Value Engineering Study Report

Georgia Department of Transportation

STP00-2584-00(009) - P.I. No. 142000

**SR 20 from Rosebud Road to Brand Road
Including One Way Pair Gwinnett/Walton Counties**

ALTERNATIVE NO.:
RD-1

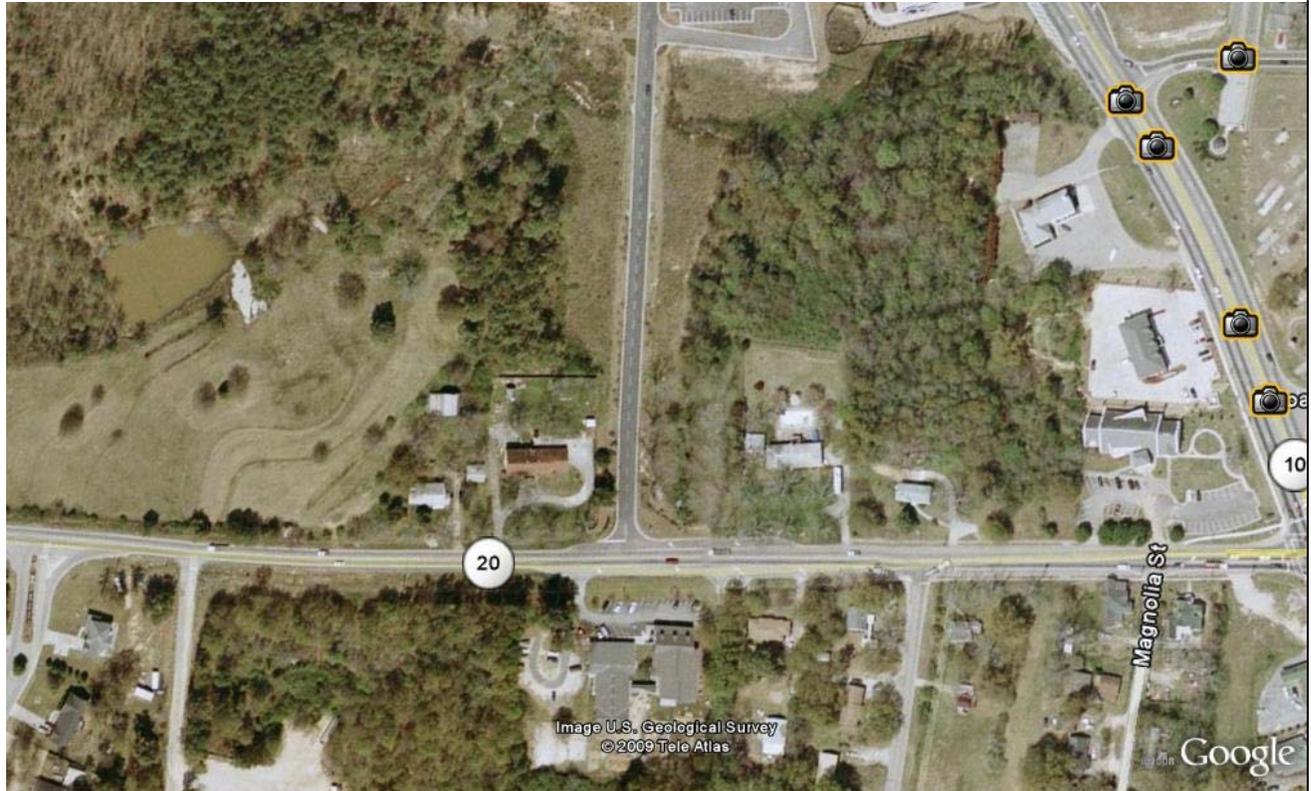
DESCRIPTION: **Do not acquire or reconstruct Publix Drive**

The original design calls for the complete reconstruction and acquisition of the existing Publix Drive.

The alternative would be to leave Publix Drive as it is, modifying only the new improved intersections. It may improve operations if this section were made to be one-way going north-west.

The existing Publix Drive was recently constructed. It appears to be in reasonable condition to not require reconstruction. Additionally, it might be prudent to make this section a one-way street heading to the north west and avoid any potential hazards with the existing day care facility

ALTERNATIVE NO.:
RD-7

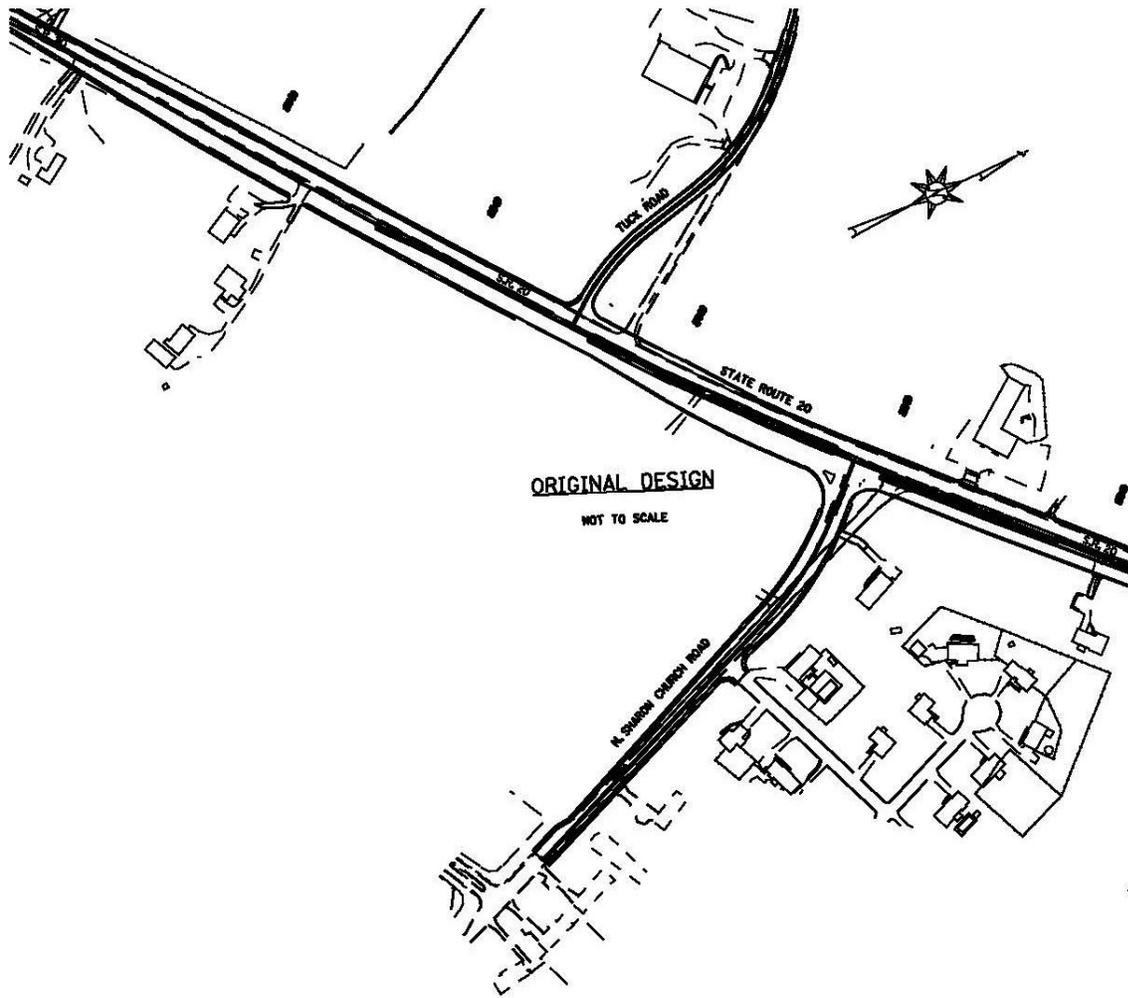
DESCRIPTION: **Relocate Tuck Road to align with Sharon Church Road**

The original design calls for re-aligning Sharon Church Road and relocating Tuck Road in order to achieve a minimum spacing between median openings.

The alternative would propose relocating Tuck Road to align with Sharon Church Road to form a single intersection. Existing Tuck Road would be connected to Sharon Church Road on the west and connected to SR 20 at its current location but with right-in/ right-out access.

By relocating Tuck Road to align with Sharon Church Road it would allow you to improve the spacing of the necessary full median openings now and any projects in the future. Consolidation of the two full median openings should also improve safety and operations, in addition to reducing overall length of the required work and the amount of required R.O.W. It should also be noted that Tuck Road will operate at LOS F before the design year of the project and will adversely affect Sharon Church Road. By relocating Tuck Road as the alternative suggests, it should improve the operation of all the roadways involved.

ALTERNATIVE NO.:
RD-8

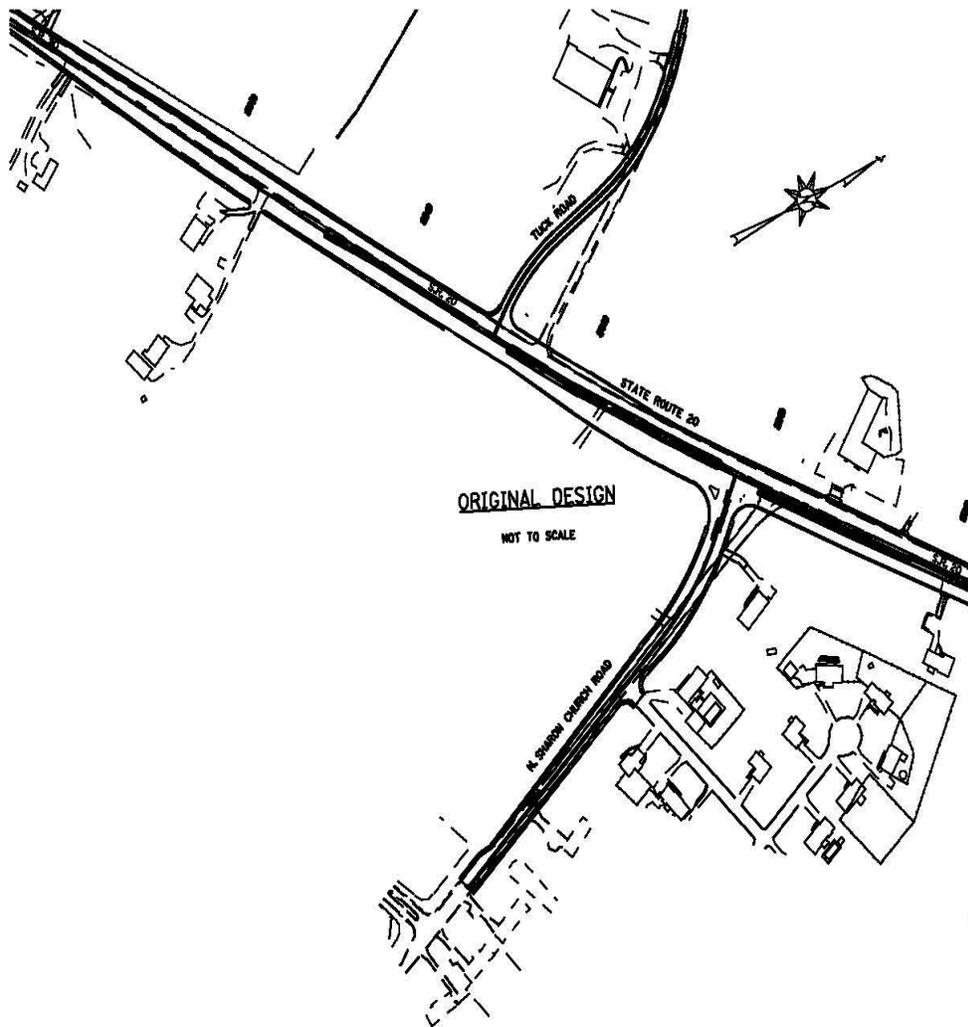
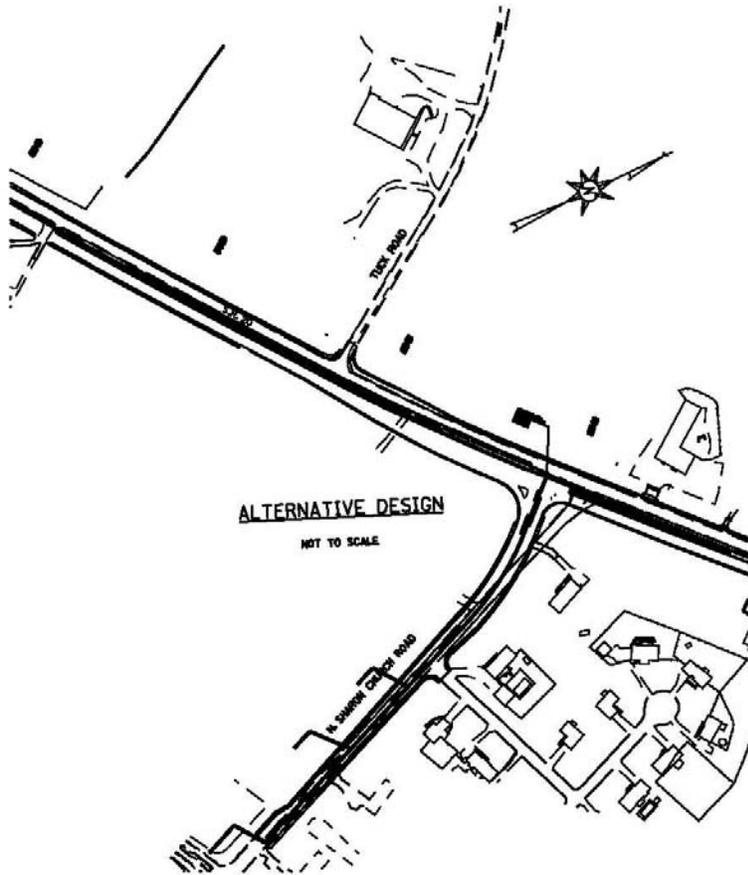
DESCRIPTION: Eliminate Tuck Road relocation

The original design calls for re-aligning Sharon Church Road and relocating Tuck Road in order to achieve a minimum spacing between median openings.

The alternative would propose eliminating the relocation of Tuck Road. Existing Tuck Road would be connected to SR 20 at its current location but with right-in right-out access. U-turns at Sharon Church Road and the end of the raised median section would provide access for Tuck Road. The raised median would be extended to Station 265+00 to provide a greater weaving section for Tuck Road traffic wishing to U-turn and proceed eastbound.

By eliminating the relocation of Tuck Road it would allow you to improve the spacing of the necessary full median openings now and any projects in the future. It should also be noted that Tuck Road will operate at LOS F before the design year of the project and will adversely affect Sharon Church Road.

ALTERNATIVE NO.:
RD-9

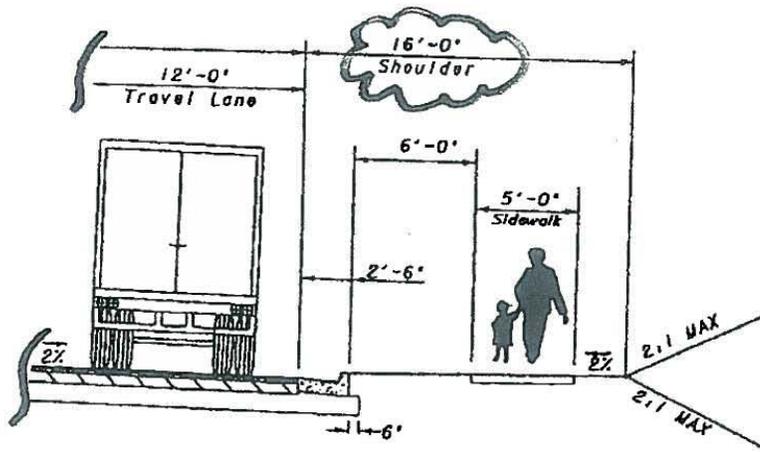
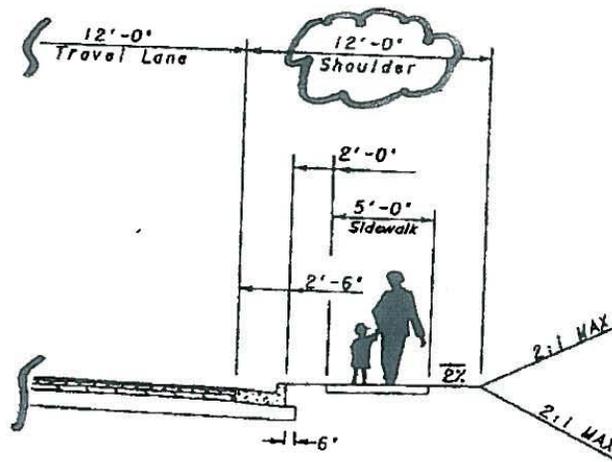
The original design calls for a 16' shoulder where sidewalk is proposed throughout the majority of the project.

The alternative would narrow the shoulder from 16' typical to 12' typical where sidewalk is placed throughout the project.

The reduction of the shoulder width from 16'-0" to 12' -0" throughout the project would allow the curb and gutter and the 5' -0" sidewalk to be constructed while reducing the ROW impact required to construct the project. The alternative would allow a 2' grassed strip from the back of curb to the front face of the 5' sidewalk, as shown in the alternative sketch.

ALTERNATIVE NO.:
RD-13

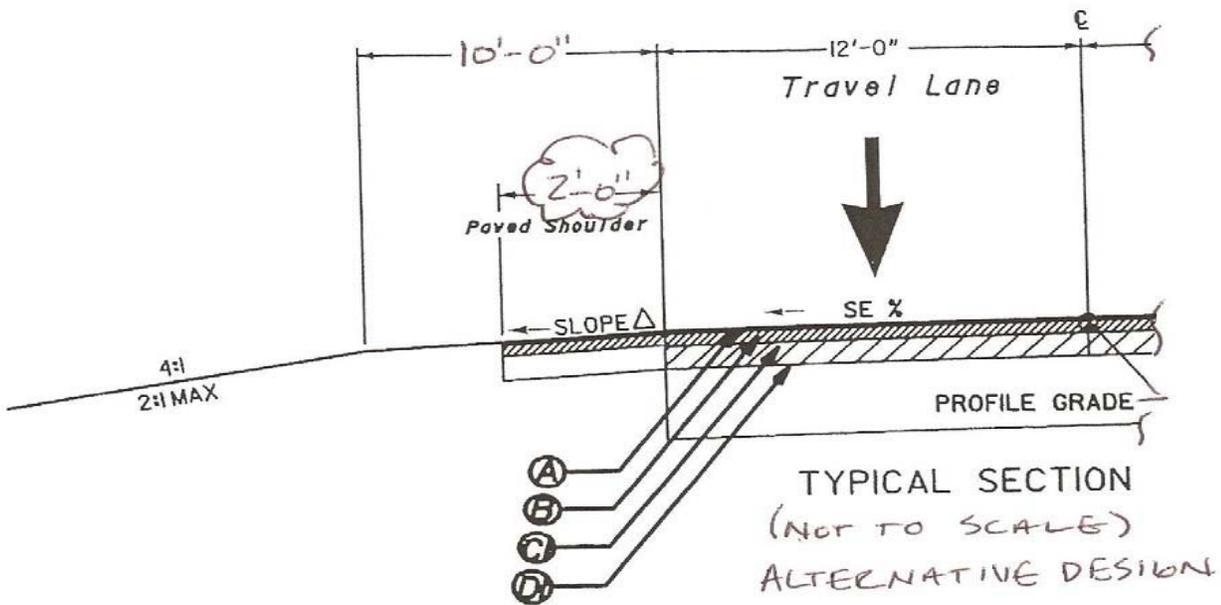
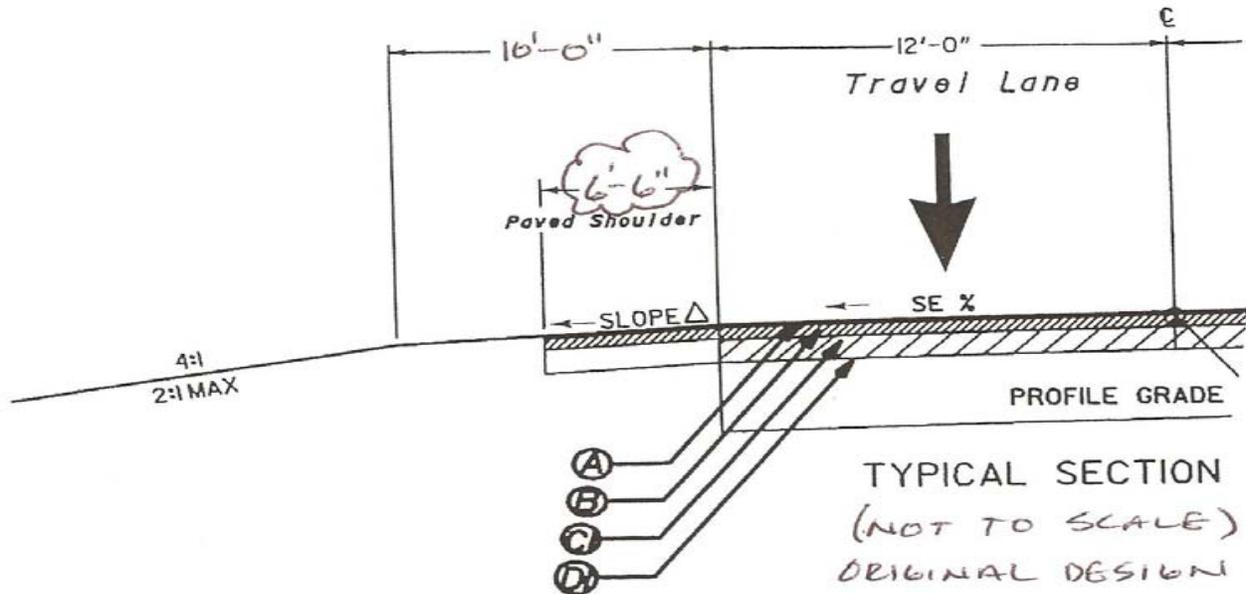
The original design calls for 6.5 foot paved shoulder.

The proposed alternative would provide 2.0 foot paved shoulder.

The original design calls for a 6.5 foot paved shoulder, however AASHTO allows as small as a 2 foot paved shoulder (AASHTO, A Policy on Geometric Design of Highways and Streets, page 314) based on the project criteria. A two foot shoulder will not provide sufficient width to accommodate pedestrian and bicycle traffic, but this type of traffic should be discouraged or restricted from this facility

ALTERNATIVE NO.:
RD-20

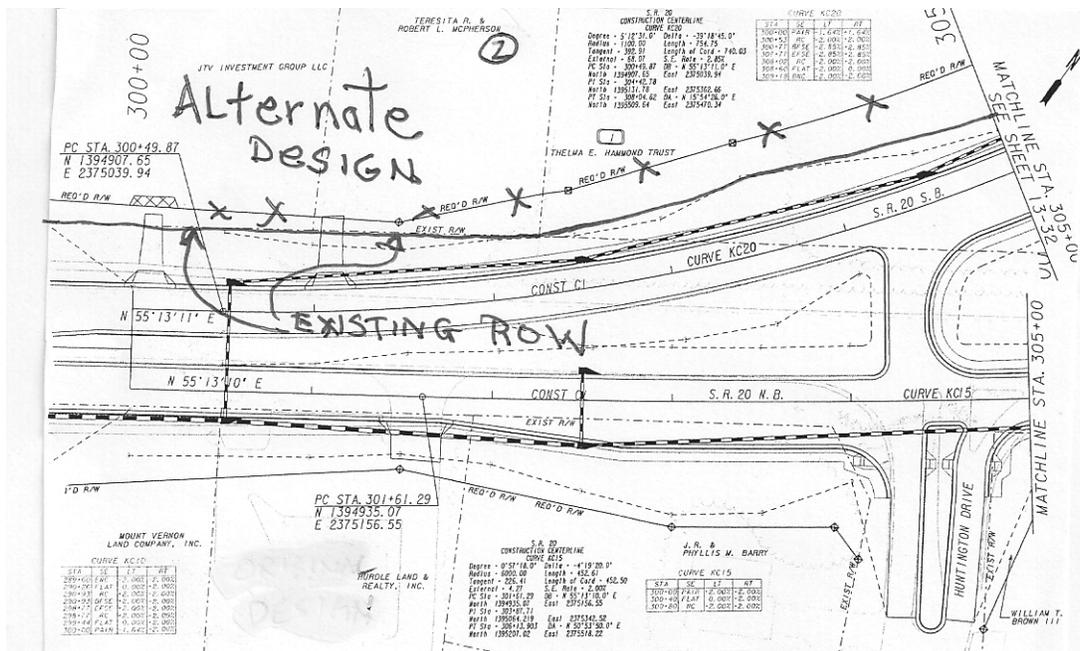
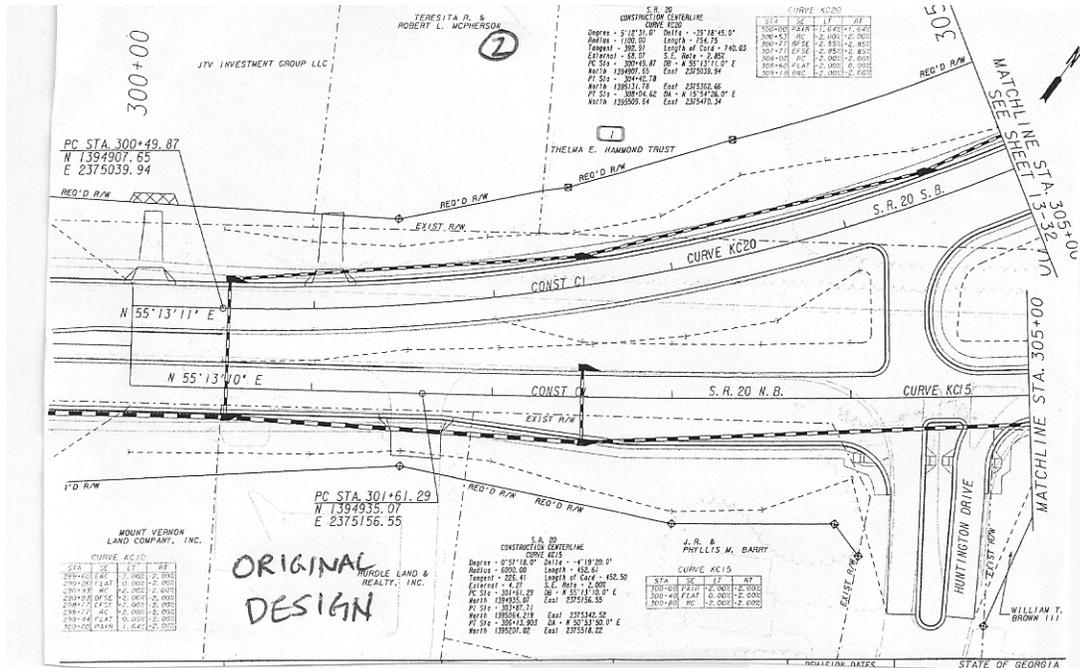
The original design at the intersection of the south westerly bound one way with SR 20, requires the taking of the existing residence to the west.

The alternative would be to revise the design, to intersect slightly to the north and east such that the proposed right-of-way line would coincide with the existing property lines thereby not relocating that resident.

It appears reasonable to slightly move the intersection to avoid the existing residence. The current design does not appear to provide for any functional requirement that a slight shift would negate.

ALTERNATIVE NO.:
RD-22

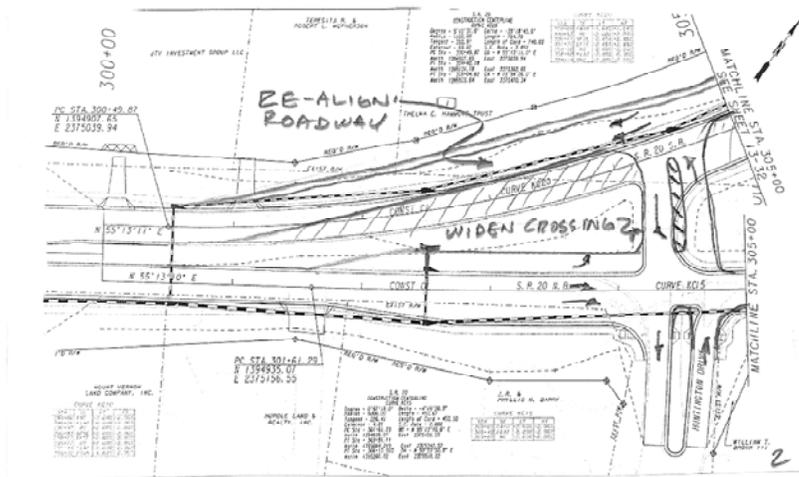
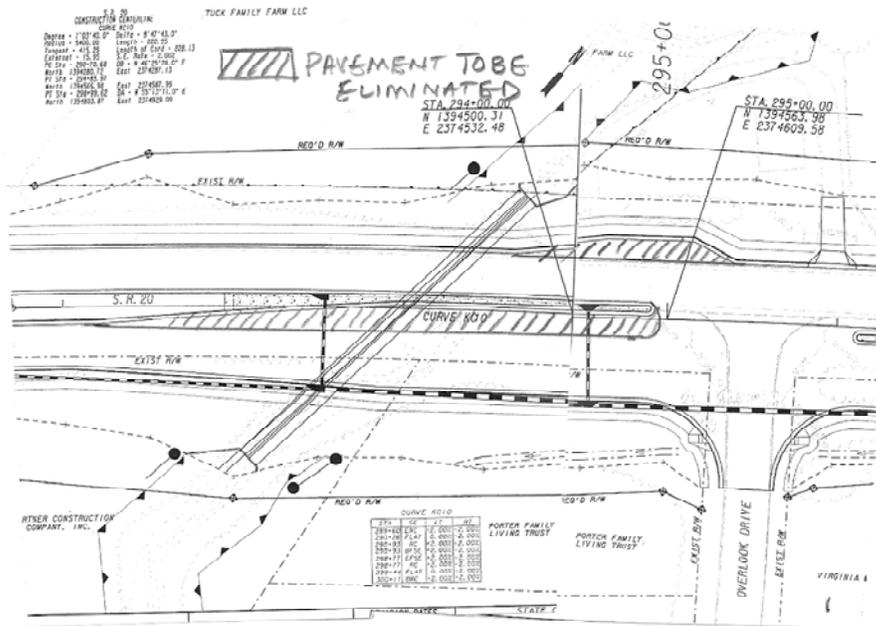
The original design calls for a u-turn with pavement eyebrows at Overlook Drive at approximately STA 295+00 on SR 20 south of the one way pair split.

The alternative would not construct the u-turn at this location.

The alternative proposes to delete the existing u-turn at STA +/-295+00 just south of the one way pairs junction. The alternative removes the pavement eyebrows, as well as the dedicated storage for u-turners in the NB lane. Removal of the eyebrow in this location will reduce the ROW required on the west side near STA 295+00, possibly minimizing or eliminating impacts to a large utility vault on the west side near STA 294+25. No costs were estimated for mitigation/elimination of this utility relocation. The VE team discussed alternatives to providing u-turn access in an alternate location, and speculated that more ROW may be required at the proposed median crossing at Huntington Drive on the west side to facilitate a wider radius to accommodate truck u-turns. This area of potential additional ROW acquisition is on property requiring a displacement in the current design. This alternative could potentially accommodate u-turn traffic with less cost and disruption.

ALTERNATIVE NO.:
RD-27

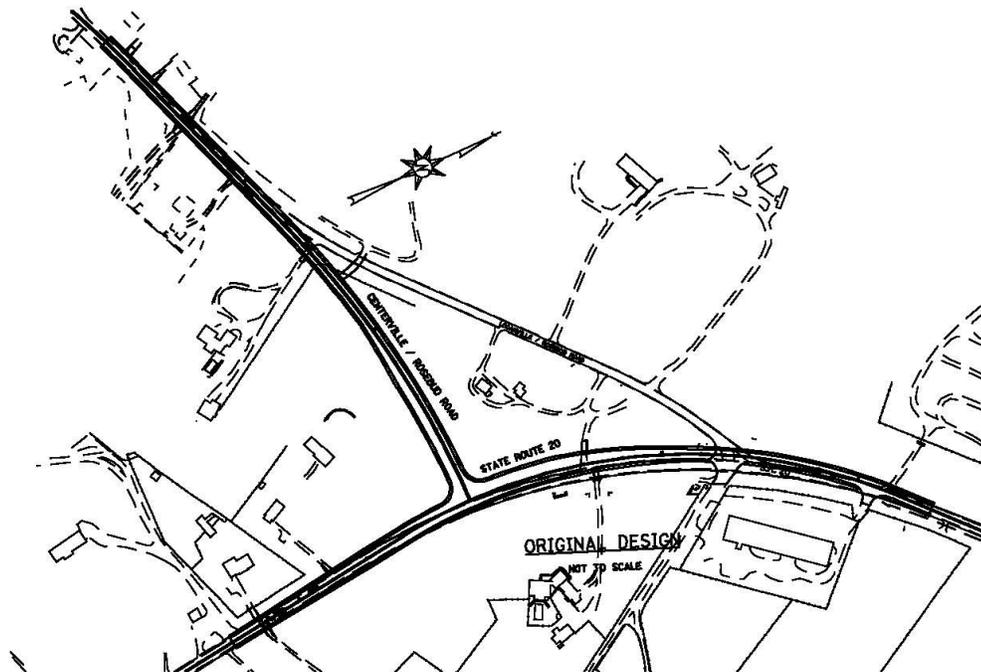
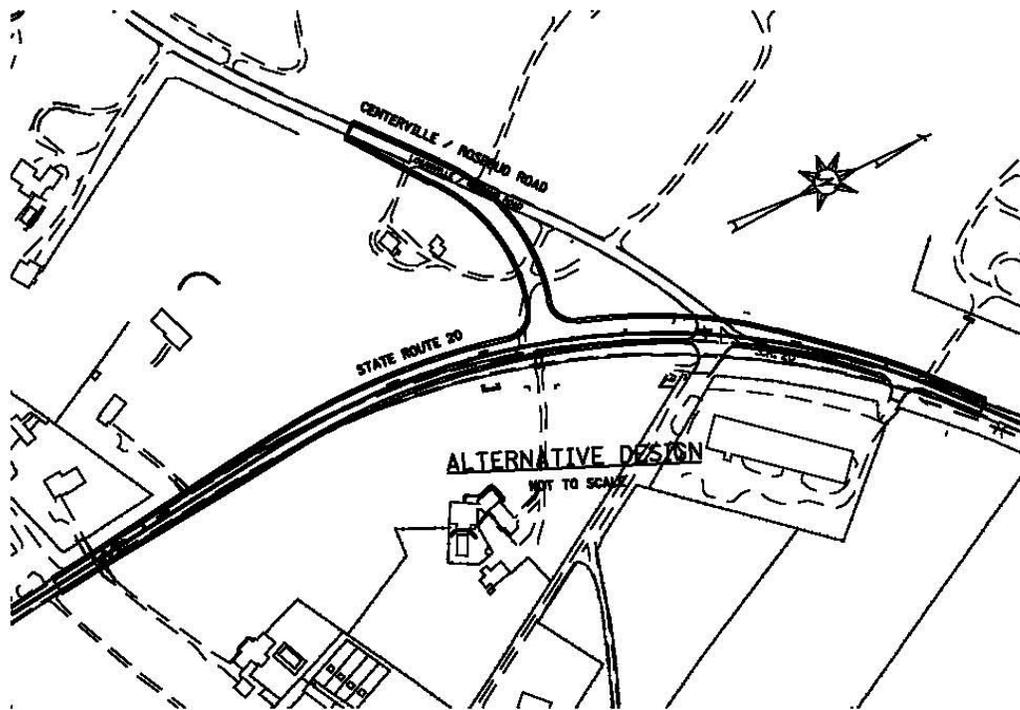
PROJECT:	Georgia Department of Transportation STP00-2584-00(009) – P.I. No. 142000 SR 20 from Rosebud Road to Brand Road, including one way pair Gwinnett/Walton Counties	ALTERNATIVE NO.:	RD- 27
DESCRIPTION:	Modify re-alignment on Centerville / Rosebud Road to the north	SHEET NO.:	5 of 5
